# VISTA PARK

COMPARISON OF OWNER'S FLORIDA DEPARTMENT OF ENVIRONMENTAL PROTECTION (FDEP) APPROVED VOLUNTARY CLEANUP ORDER (VCO) APPROACH AND CORPS OF ENGINEER'S (COE) APPROACH TO CLEARANCE OF THE VISTA PARK PROPERTY.

Figure 2 - Bomb craters in the southern part of the property from 1947 aerial

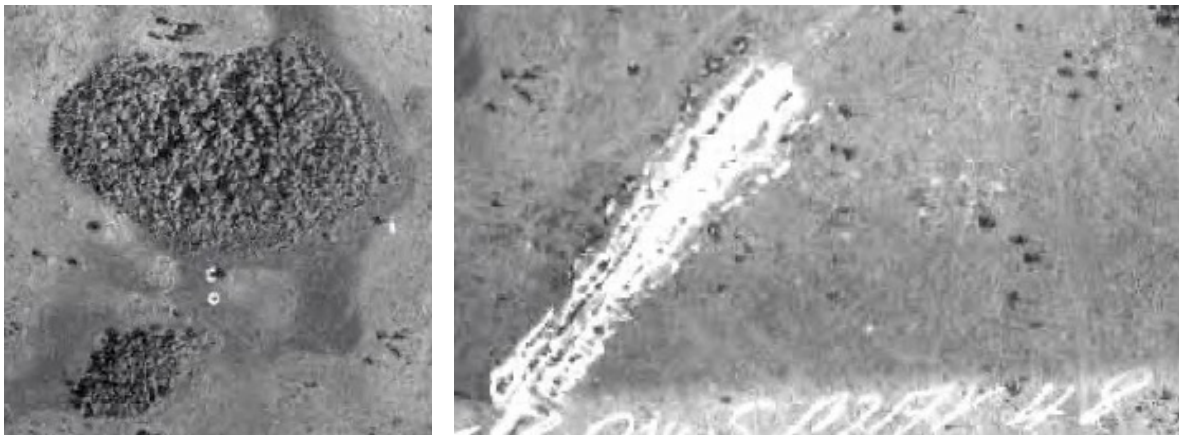
- The CoE approach has declared that there is no risk of UXO in the southern part of the property even though their own documentation shows bomb impact craters in historical aerial photos (1947) and their field investigation (2008/2009) recovered Munitions Debris from expended military munitions. The CoE contractor field records only document these items as "Munitions Debris Non Specific" and "Munitions Debris Frag". The identification of Munitions Debris fragmentation strongly indicates that high explosives munitions were utilized in this part of the property as the fragmentation is usually the result of high explosive detonation. It is probable that malfunctioned unexploded munitions items are also present in the vicinity. The Probable Bomb Impact Analysis carried out by the St Louis District of the CoE in 2007 identified target #6 Airstrip Target as being in the southern part of the property. The finding of no risk is onrtrary to the documented evidence.
